Entergy Operations, Inc.
1448 S.R. 333
Russellville, AR 72801
Tel 501-858-4888

SUBJECT: Arkansas Nuclear One, Unit 2
Docket No. 50-368
License Amendment Request to Change the Spent Fuel Pool (SFP)
Loading Restrictions

Attachment 1

Analysis of Proposed Technical Specification Change

**ANO-2 Spent Fuel Pool Arrangement
Figure 3.9.1**

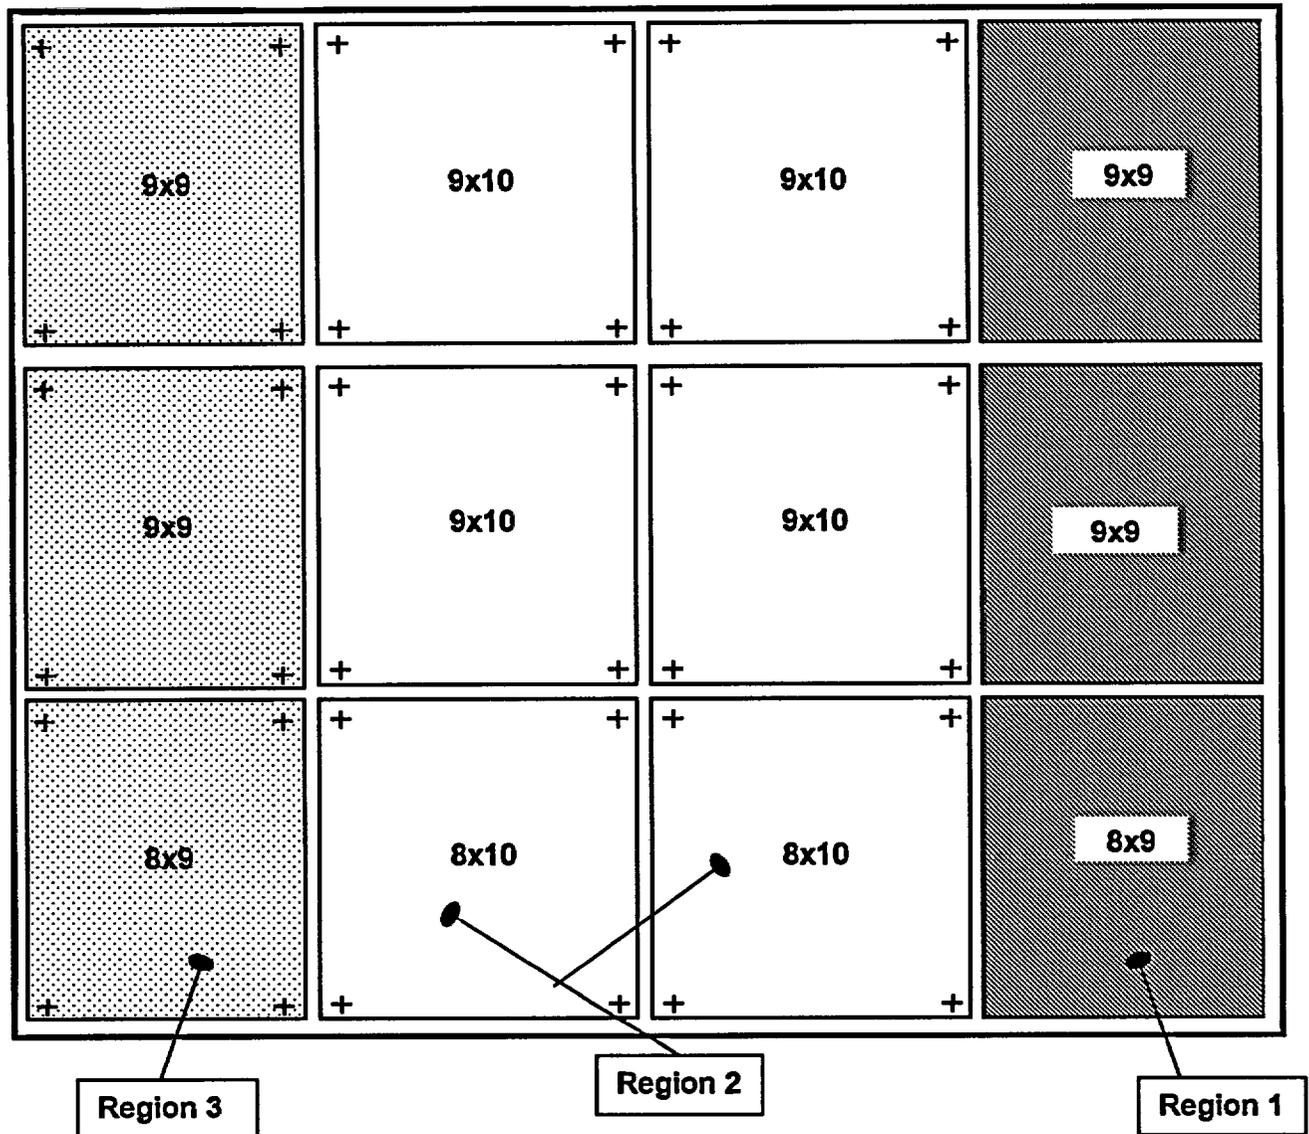
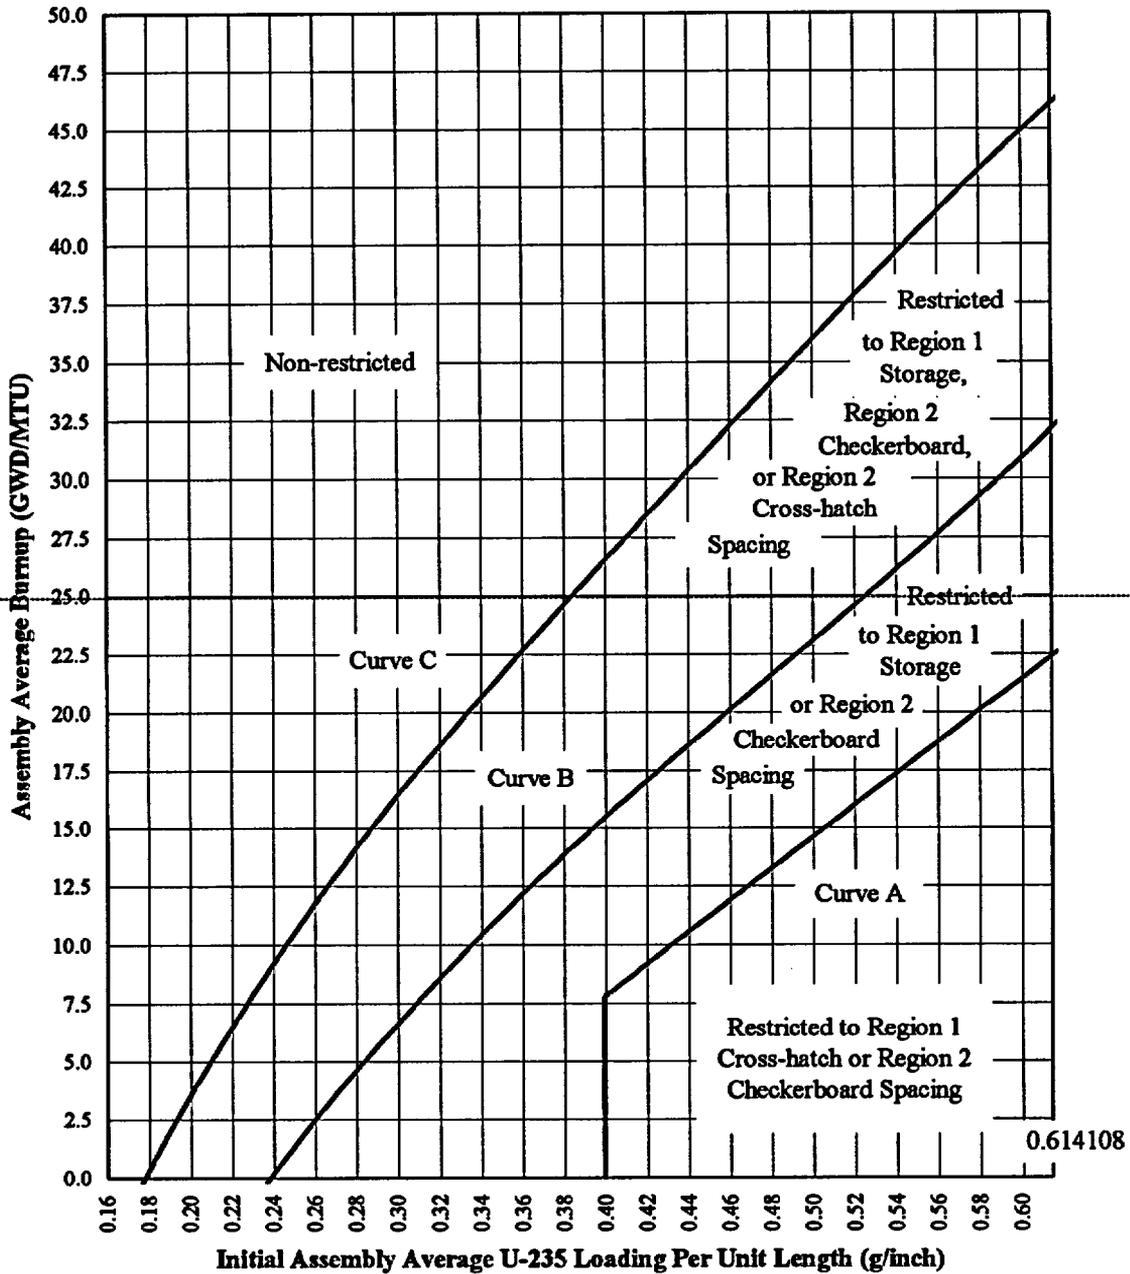
- 3.9.12.b Storage in Region 1 or Region 2 (as shown on Figure 3.9.1) of the spent fuel pool shall be further restricted by the limits specified in Figures 3.9.2 and 3.9.3. ~~In the event a cross-hatch storage configuration is deemed necessary for a portion of either Region 1 or Region 2, vacant spaces diagonal to the four corners of any fuel assembly or vacant spaces on two opposite faces of any fuel assembly shall be physically blocked before any such fuel assembly may be placed in that region (Note 1). Also, the Region 1 storage cells adjacent to the Region 2 interface are restricted to fuel assemblies that are outside of the area of the graph enclosed by Curve A on Figure 3.9.2. In the event a checkerboard storage configuration is deemed necessary for a portion of Region 2, vacant spaces adjacent to the four faces of any fuel assembly shall be physically blocked before any such fuel assembly may be placed in Region 2.~~ The provisions of Specification 3.0.3 are not applicable.

Figure 3.9.2
Bumup versus Initial Assembly Average U-235 Enrichment
Region 1

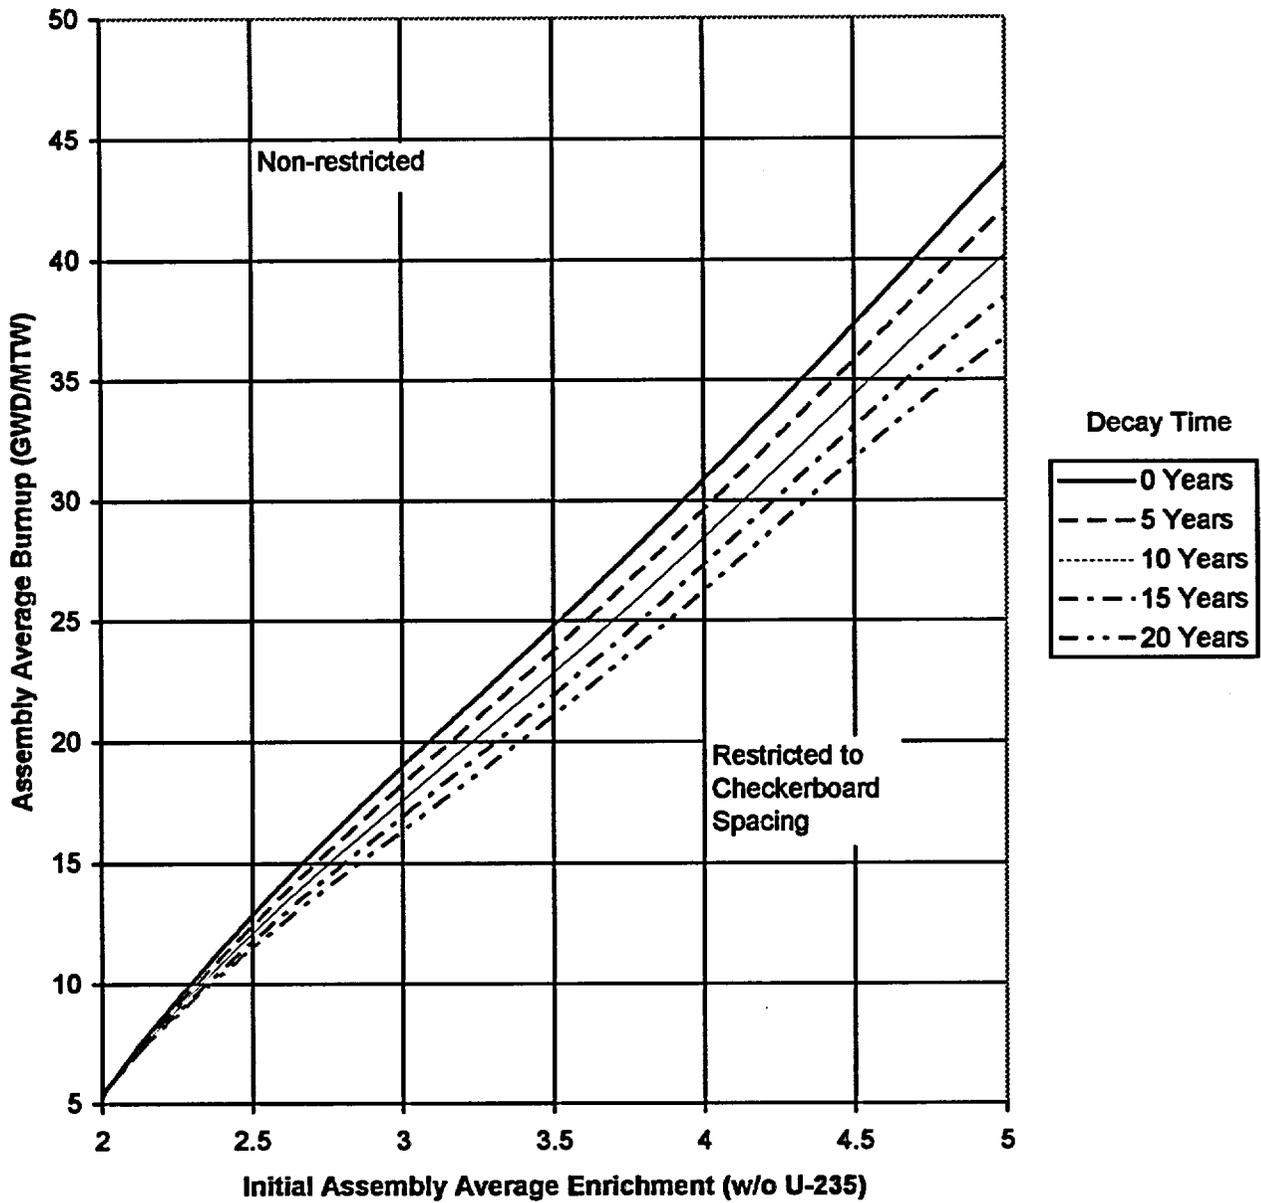
To best reflect the loading restrictions in the two regions, a new figure will be added for Region 2 while the current Figure 3.9.2 will reflect the loading restrictions for Region 1.

Boraflex® in Region 1 and will include new loading restrictions for Region 1. Based on the new criticality analysis, new restrictions will also be imposed on Region 2. This will result in changes to TS 3.9.12.b and Figure 3.9.2. The new Figure 3.9.2 will depict loading restrictions for Region 1 and a new Figure 3.9.3 will be added for the loading restrictions in Region 2 such that loading restrictions for Region 1 and Region 2 are reflected on separate figures. In addition, a portion of the current Region 2 SFP racks will be modified by the installation of Metamic® poison panel inserts. This will result in the creation of a new Region 3 which will allow unrestricted storage of new and spent fuel. The creation of the new region will require a change to TS Figure 3.9.1. Entergy has submitted a topical report to allow the use of Metamic® in SFP applications. Approval of the topical report is required to support this submittal.

Note 1 associated with TS 3.9.12.b allows storage of fuel assemblies in the vacant spaces created in the most peripheral row/column of Region 1 as required by Curve A on TS Figure 3.9.2. The new criticality analysis redefines loading restrictions for Region 1; therefore, this note is no longer applicable and will be deleted.

SR 4.9.12.b requires verification that the fuel assemblies that will be placed in the SFP are within the limits of Figure 3.9.2. The proposed change will modify this SR to reflect the addition of a new curve to ensure that the current requirement is maintained.
